**PLANNED UNIT DEVELOPMENT
& SUBDIVISION STAFF REPORT****Date: October 16, 2008****SUBDIVISION NAME**

The Village of Midtown Subdivision

Planned Unit Development Approval to allow a 15-building, 324-unit apartment complex with associated accessory structures and parking garages on a single building site and Subdivision approval to create one legal lot from four legal lots of record.

APPLICATION NUMBER 31 & 32 DATE October 16, 2008

SUBDIVISION PLAT

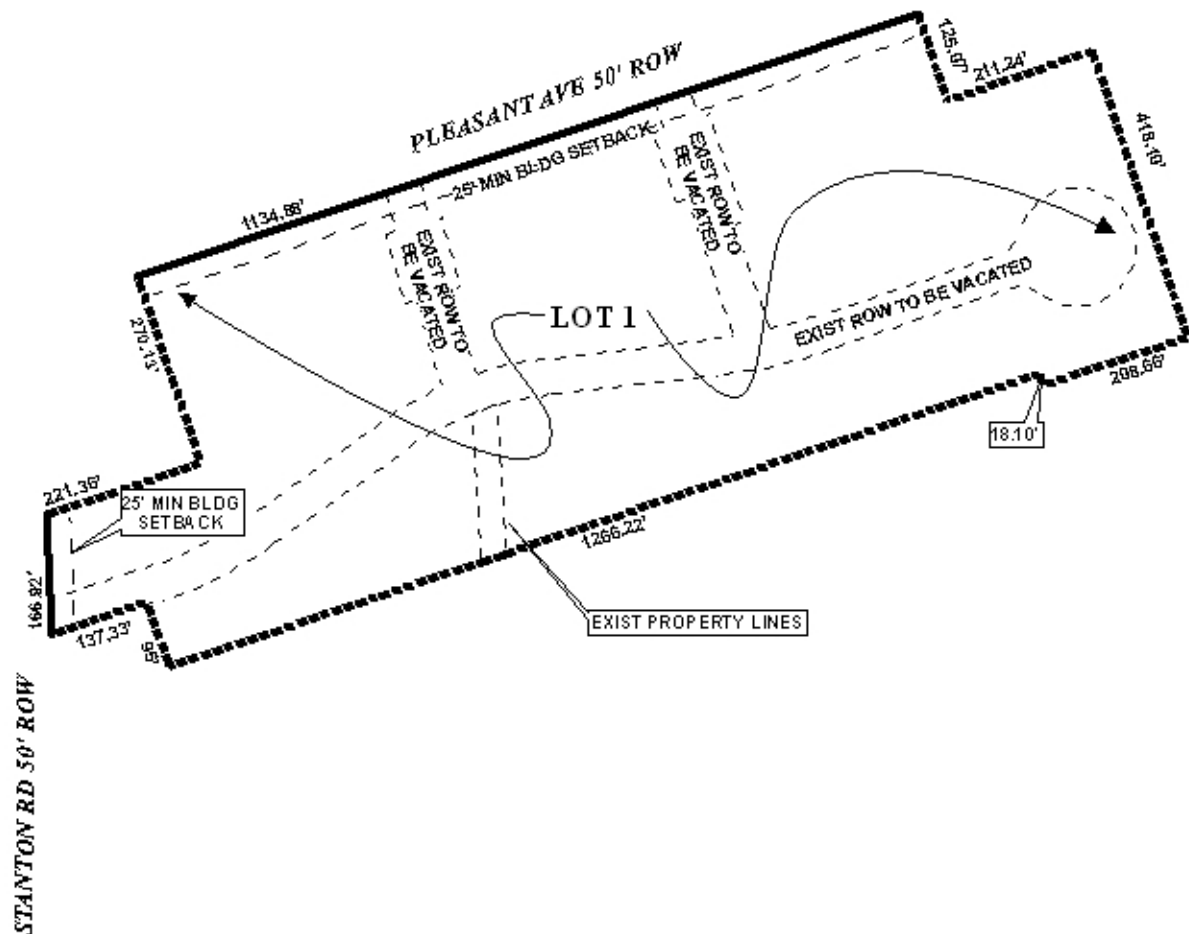
- 1) labeling of all common areas, and placement of a note on the site plan and plat stating that maintenance of common and detention common areas is the responsibility of the property owners;
- 2) depiction and labeling of the minimum building setback line from all street frontages;
- 3) completion of the vacation process prior to the signing of the Final Plat;
- 4) full compliance with Urban Forestry comments, and placement of the comments as a note on the site plan and plat (*Property to be developed in compliance with state and local laws that pertain to tree preservation and protection on both city and private properties (State Act 61-929 and City Code Chapters 57 and 64). Preservation status is to be given to all 50” and larger trees that may occur within the development, not otherwise identified. Any work on or under these trees are to be permitted and coordinated with*

- 5) placement of a note on the site plan and plat stating that the site must be developed in compliance with all local, state and Federal regulations regarding endangered, threatened or otherwise protected species;
- 6) submission and completion of the Traffic Impact Study prior to the signing of the Final Plat;
- 7) the placement of a note on the Final Plat stating approval of the park access from this development must be approved by the City of Mobile Parks and Recreation Department;
- 8) provision of two (2) revised PUD site plans to the Planning Section of Urban Development prior to the signing of any Subdivision plat; and
- 9) full compliance with all other municipal codes and ordinances.

SITE PLAN

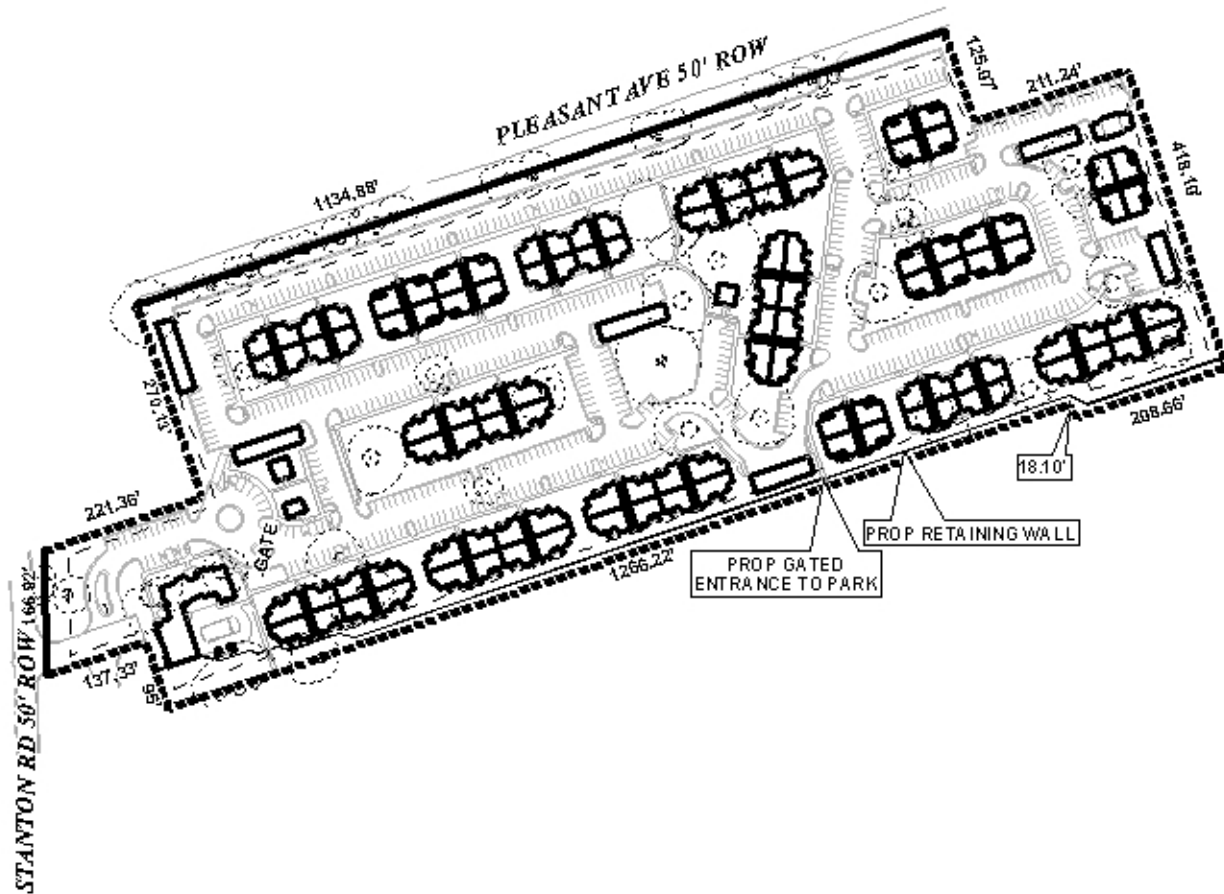
The proposed 16.9± acre, 1-lot subdivision fronts Stanton Road and Pleasant Avenue, both minor streets which provide 50-feet of right-of-way, as illustrated on the preliminary plan and site plan. However, access management is a concern; therefore, the proposed development is required to submit a Traffic Impact Study to allow Traffic Engineering and Urban Development to assess the traffic volume and patterns, existing and proposed.

As indicated on the proposed site plan and access to a public park is illustrated. This access should be approved by the City of Mobile Parks and Recreation Department; therefore, a note should be placed on the Final Plat and PUD Site Plan stating the approval by the City of Mobile Parks and Recreation Department.

The location of the proposed entrance/exit into the proposed apartment complex raises concerns of conflicts relating to turning movements. Furthermore, the volume of traffic generated by the apartment complex and the nearby residences and businesses near this location is of great concern. As illustrated on the preliminary plat it seems that the apartment complex entrance from Pleasant Avenue will require redesign/relocation due to the absence of minimum 60-feet to provide sufficient stacking area. In addition due to the location and size of the development, the proposed development is required to submit a Traffic Impact Study to allow Traffic Engineering and Urban Development to assess the traffic volume and patterns, existing and proposed.

The applicant is proposing a “multi-family” PUD residential development, and consequently, PUD landscape area requirements apply. Section 64-5.C.2. of the Zoning Ordinance requires 700 square feet of open space per dwelling unit, which cannot include streets, drainageways, parking areas, service areas and land covered by buildings. Furthermore, compliance with the tree and landscaping requirements of the Zoning Ordinance will be required. Information on the site plan indicates that adequate area will be available for compliance with the landscaping and tree requirements of the Zoning Ordinance.

- 1) labeling of all common areas, and placement of a note on the site plan and plat stating that maintenance of common and detention common areas is the responsibility of the property owners;

- 2) depiction and labeling of the minimum building setback line from all street frontages;
- 3) completion of the vacation process prior to the signing of the Final Plat;

- 6) submission and completion of the Traffic Impact Study prior to the signing of the Final Plat;
- 7) the placement of a note on the Final Plat stating approval of the park access from this development must be approved by the City of Mobile Parks and Recreation Department;

- 8) provision of two (2) revised PUD site plans to the Planning Section of Urban Development prior to the signing of any Subdivision plat; and
- 9) full compliance with all other municipal codes and ordinances.
